Access Compliance Report

Public Rights-of-Way

(Curb Ramps)

Intersection ID: 46182	Main Street: SEVEN_OAKS_DR	Cross Street: GLOXINIA_RD	Location: NE
ADA ID: 389DE5D4C5F3	Ramp Type: PerpDiag	Initial Pass/Fail: Fail	Overall Compliance: No
Severity Score: 10			
Codes/Mitigation Info/Possible Solution		Field Measurements/Component Compliance

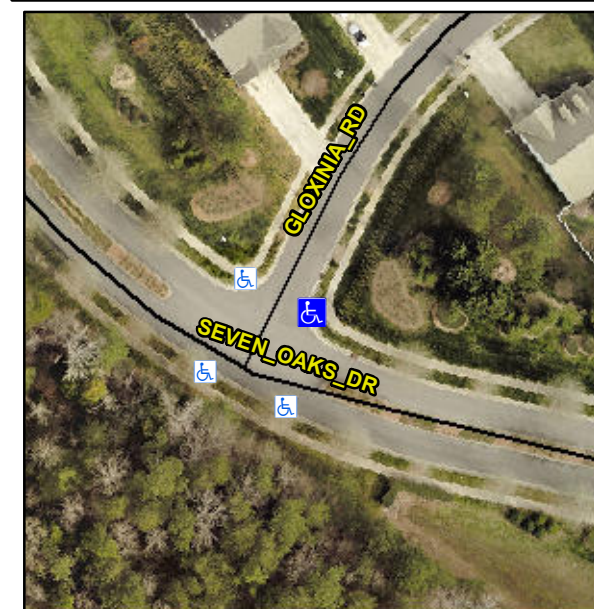
Not Found, R304.5.1, R304.5.3

Compliance	Description	Data	Compliance	Description	Data
N/A	Ramp Length (in)	97.0	Yes	Ramp Slope (%)	7.1
No	Ramp Width (in)	47.0	No	Ramp XSlope (%)	2.1
N/A	Flare Type LT	N/A	N/A	Flare Type RT	N/A
N/A	Flare Slope LT (%)	N/A	N/A	Flare Slope RT (%)	N/A
N/A	Flare Traversable LT?	N/A	N/A	Flare Traversable RT?	N/A
N/A	Landing Length (in)	N/A	N/A	DWS Provided?	N/A
N/A	Landing Width (in)	N/A	N/A	DWS Contrast?	N/A
N/A	Landing Slope (%)	N/A	N/A	DWS Length (in)	N/A
N/A	Landing X Slope (%)	N/A	N/A	DWS Full Width?	N/A
N/A	Landing Curb? (Y/N)	N/A	N/A	DWS Offset (in)	N/A
N/A	Shared Landing?	N/A			
N/A	Gutter Ponding?	N/A	N/A	Gutter Slope (%)	N/A
N/A	Gutter Lip Ht (in)	N/A	N/A	Gutter X Slope (%)	N/A
N/A	Painted X Walk1?	No	N/A	Painted X Walk2?	No
	X Walk 1 Direction	To NW		X Walk 2 Direction	To SW
N/A	X Walk 1 Width (in)	N/A	N/A	X Walk 2 Width (in)	N/A
	X Walk 1 Slope (%)	0.1		X Walk 2 Slope (%)	2.2
	X Walk 1 X Slope (%)	3.0		X Walk 2 X Slope (%)	1.0

Remove & Replace Curb Ramp With Two New Directional Ramps or Equivalent.
